To: T10 Technical Committee
From: Robert Sheffield (Robert.L.Sheffield@intel.com), Intel Corporation
Date: ~~August 8, 2003~~October 22, 2003
Subject: T10/03-273r1T10/03-273r0 SAS-1.1 Support for SATA Port Selector

Figure 59 – SATA port selection signal

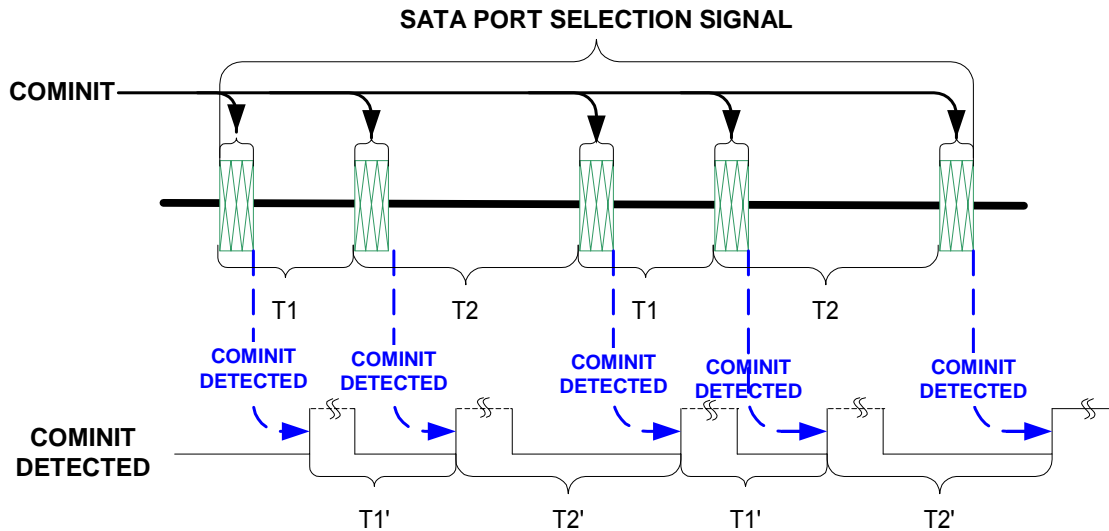
Add the following text and figure after the last paragraph in sub clause 6.5 Out of band (OOB) signals:

If an expander device supports control of a SATA port selector attached to any of its phys, it shall be capable of generating the SATA PORT SELECTION SIGNAL as shown in figure 59 to cause the attached SATA port selector to select the attached phy as the active phy. The generated SATA PORT SELECTION SIGNAL shall be composed of 5 COMINIT signals, each starting a specified time interval, T1 or T2 as shown in Figure 59, after the start of the previous COMINIT signal. The values of T1 and T2 shall be as shown in Table 1.

Figure 70 - SP (phy layer) state machine - SATA Port Selection management state

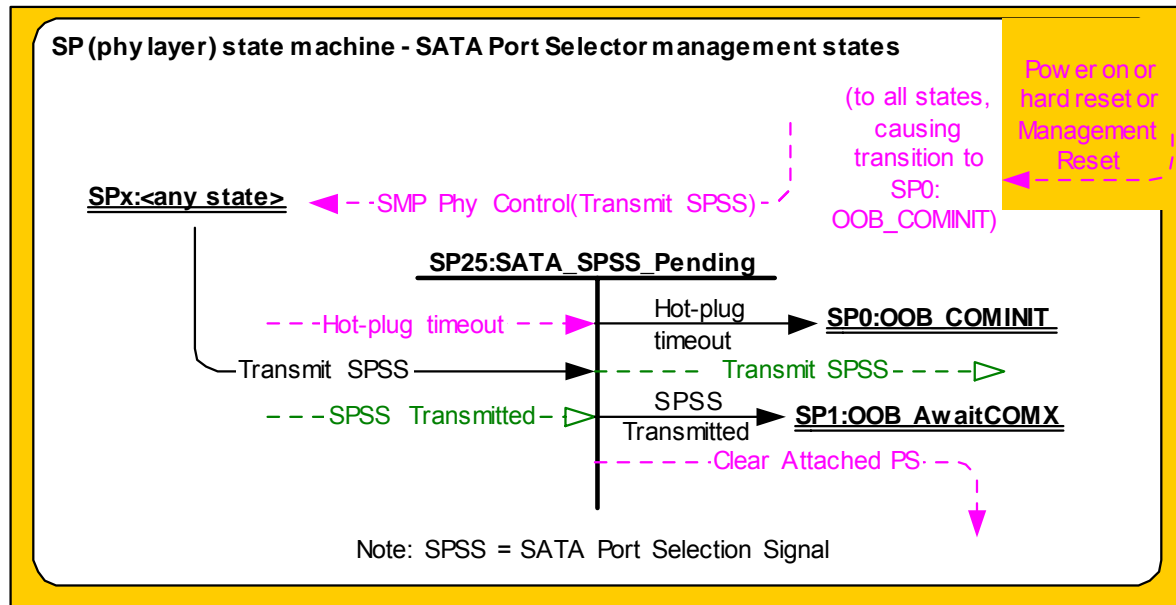
Add sub clause 6.7.6 as follows:

Figure 70 shows the SATA Port Selector management state. This state controls transmission of the SATA Port Selection signal (SPSS) when a specified phy processes an SMP Phy Control (TRANSMIT SATA PORT SELECTION SIGNAL) request.

If the phy supports attachment of a SATA device and attachment of a SATA Port Selector, a transition shall occur from any SP state to this state upon receipt of an SMP Phy Control function for the phy specifying a PHY OPERATION of TRANSMIT SATA PORT SELECTION SIGNAL (TSPSS). The phy shall transmit the SATA PORT SELECTION SIGNAL (see table 163 – phy operation and sub clause 6.5 – out of band signals). This transition shall clear the ATTACHED PS bit in the DISCOVER Response.
